**2nd 45-DAY EXPRESS TERMS
FOR
PROPOSED BUILDING STANDARDS
OF THE
DIVISION OF THE STATE ARCHITECT-ACCESS COMPLIANCE
CONCERNING
2007 CALIFORNIA BUILDING CODE
CALIFORNIA CODE OF REGULATIONS, TITLE 24, PART 2**

2007 Code Cycle

Item 13. Proposed code change(s):

FIGURE 11B-35 - WARNING STRIPING AND HANDRAIL EXTENSIONS

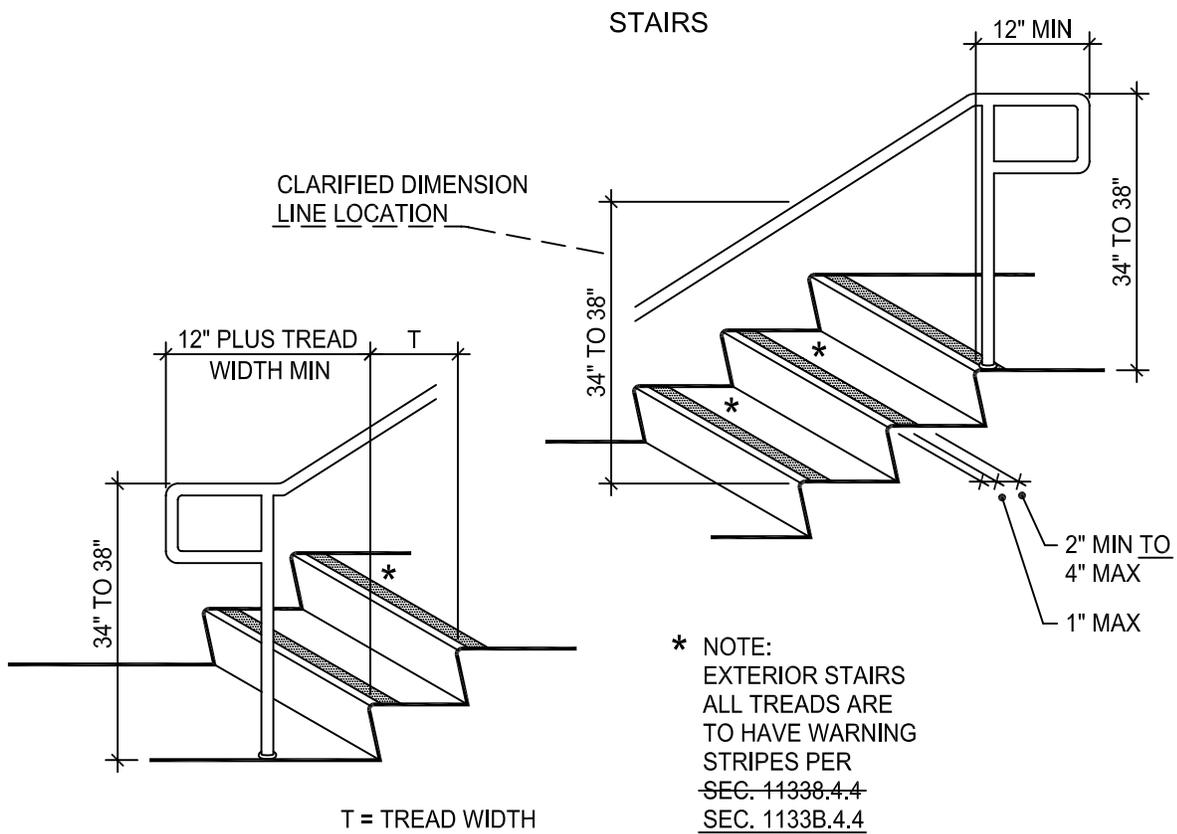
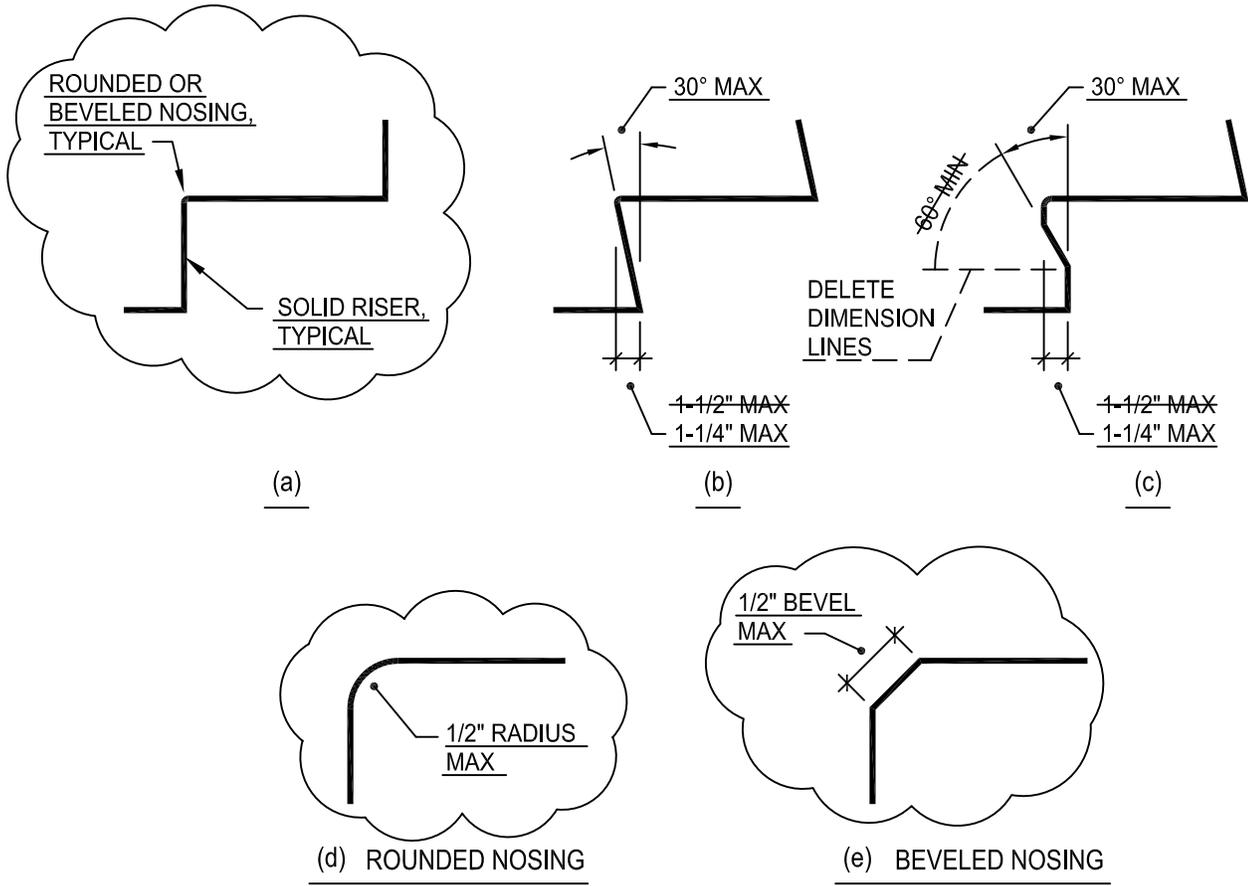
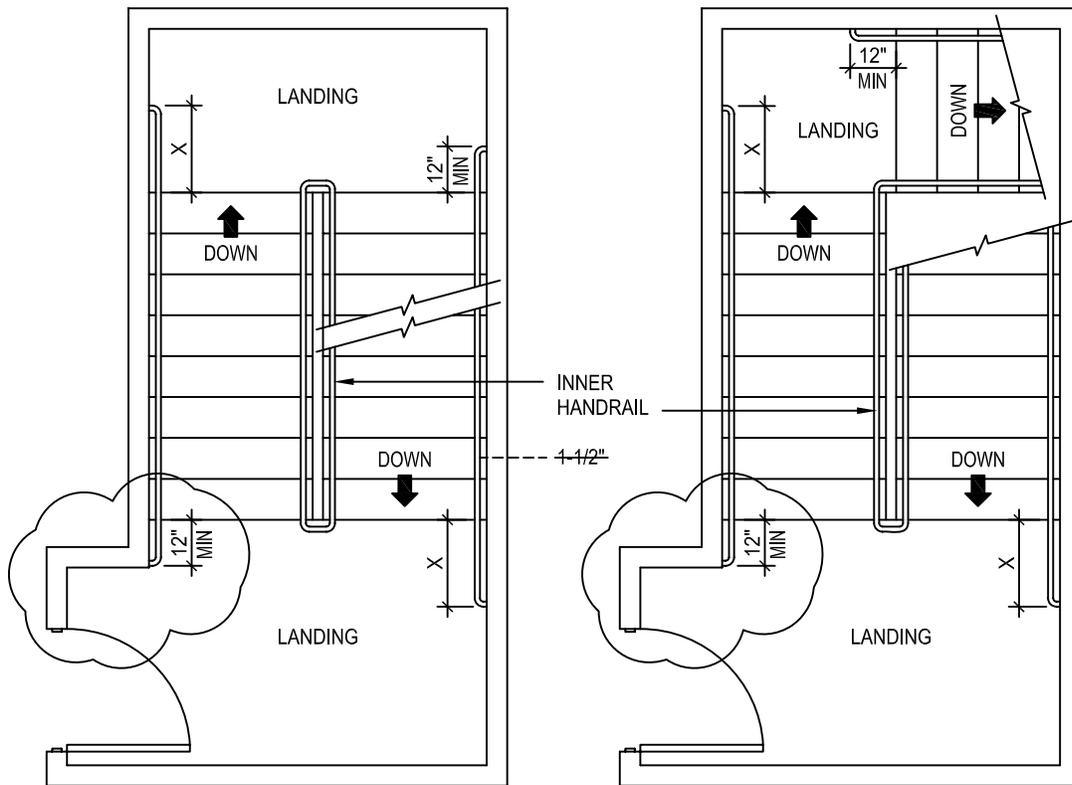
1133B.4.5.2 Risers. Risers shall be solid and shall be vertical (see Figure 11B-35(a)) or sloped from the underside of the leading edge of the tread above at an angle not more than 30 degrees (0.52 rad) from the vertical (see Figure 11B-35(b)). Open risers are not permitted.

~~1133B.4.5.2~~ **1133B.4.5.3 Nosing.** The radius of curvature at the leading edge (nosing) of the tread shall be no greater than 1/2 inch (12.7 mm). Beveling of nosings shall not exceed 1/2 inch (12.7 mm). Nosings shall not project more than 4-1/2 1-1/4 inches (38 mm) (31.8) past the face of the riser below. Nosings that project beyond risers shall have the underside of the leading edge beveled at an angle not more than 30 degrees (0.52 rad) from the vertical (see Figure 11B-35(c)). The transition from the nosing to the riser shall be free of abrupt edges. All projections shall be of uniform size, including nosings at landings.

FIGURE 11B-35 – WARNING STRIPING AND HANDRAIL EXTENSIONS

Related code change to Item 47

X = EXTENSION OF HANDRAIL SHALL BE EQUAL TO THE TREAD WIDTH PLUS 12 INCHES MINIMUM

FIGURE 11B-37 - STAIR HANDRAILS

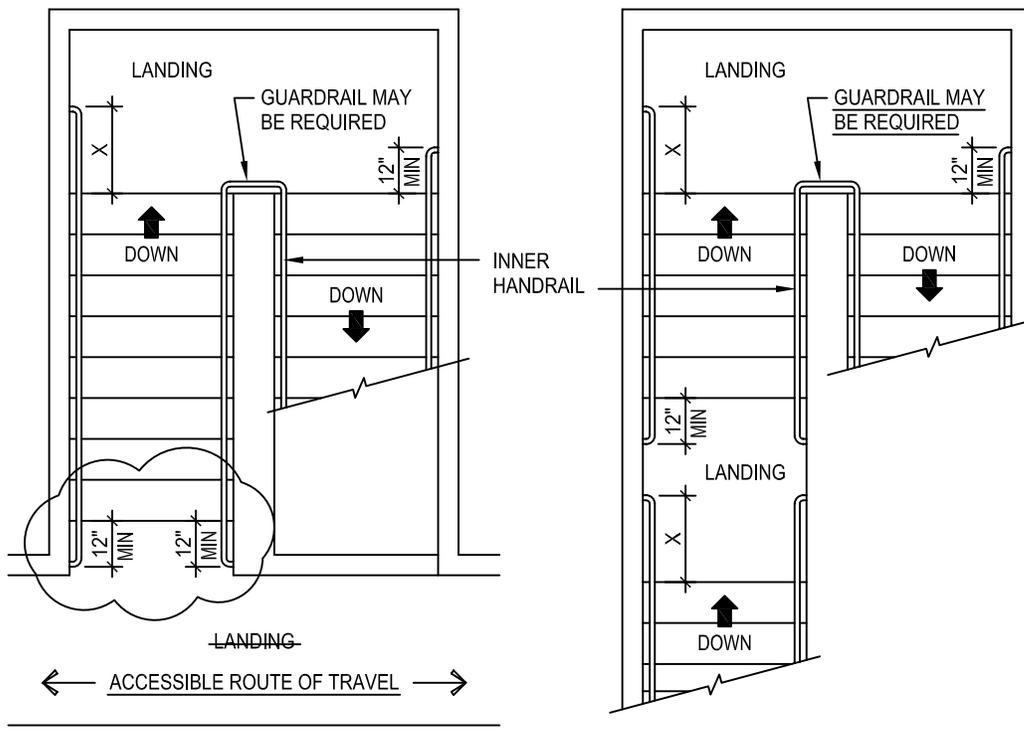
FIGURE 11B-37 – STAIR HANDRAILS

Related to 2007 California Building Code Section 1133B.4.2.2

1133B.4.2.2 *Handrails shall extend a minimum of 12 inches (305 mm) beyond the top nosing and 12 inches (305 mm), plus the tread width, beyond the bottom nosing. At the top, the extension shall be parallel with the floor or ground surface. At the bottom, the handrail shall continue to slope for a distance of the width of one tread from the bottom riser; the remainder of the extension shall be horizontal. See Figures 11B-35 and 11B-37.*

NOTE: INNER HANDRAIL AT LANDINGS OF STAIRS THAT DOUBLE BACK OR IMMEDIATELY TURN SHALL BE CONTINUOUS AND SHALL NOT EXTEND INTO LANDING OR PATH ACCESSIBLE ROUTE OF TRAVEL
